SERVICE BULLETIN

NO. A2972-78-3

POWER PLANT - FAN COWLING - HOLD OPEN ROD
INSPECT AND REPLACE END FITTING

**STRUT ASSEMBLY
A2972-1, A2972-2, OR A2972-21
IPL FIGURE 1**

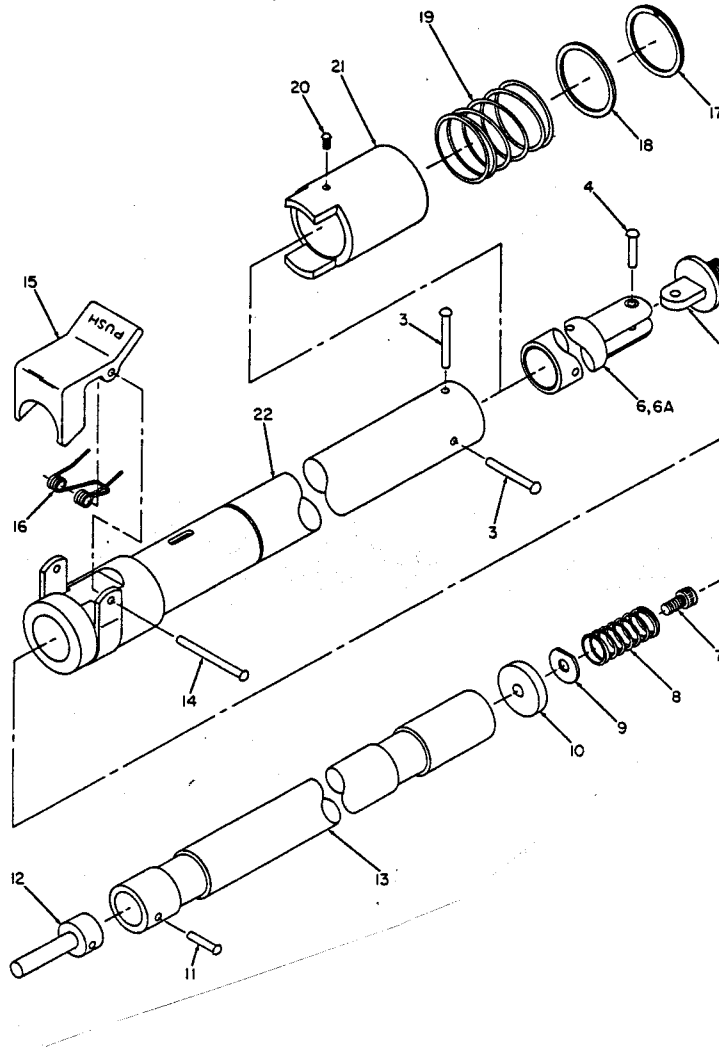
- (1) Locate the threaded end of the clevis fitting, item 5, shown in Figure 1.
- (2) Determine if the end of the fitting can be cleaned and inspected on the aircraft. The hold open rod should be removed from the aircraft if access to the end of the fitting is limited.

- (3) Clean the end of the fitting using a soft non-metallic brush moistened with 1-1-1 trichloroethane solvent or equivalent. Wipe end of fitting with clean cloth until cloth comes away clean.
- (4) Visually inspect the end of the fitting for any evidence of porosity. Porosity may appear as a dark spot, crack, or cavity. Replace fitting if end shows any evidence of porosity.

- (1) Remove rivet, item 4, by drilling out manufactured head using a 0.1562 inch (3.97 mm) diameter drill.
- (2) Punch out rivet, item 4, and remove clevis fitting, item 5, from clevis end plug, item 6, 6A.

- (1) Place new clevis fitting (P/N AM2972-1-13), item 5, in clevis of end plug fitting, item 6, 6A. Insert new rivet (MS20613-5C14) and check that new fitting rotates freely 180°.
- (2) Spin or form head on unfinished end of new rivet, item 4.

Item numbers correspond to those shown in Figure 1.
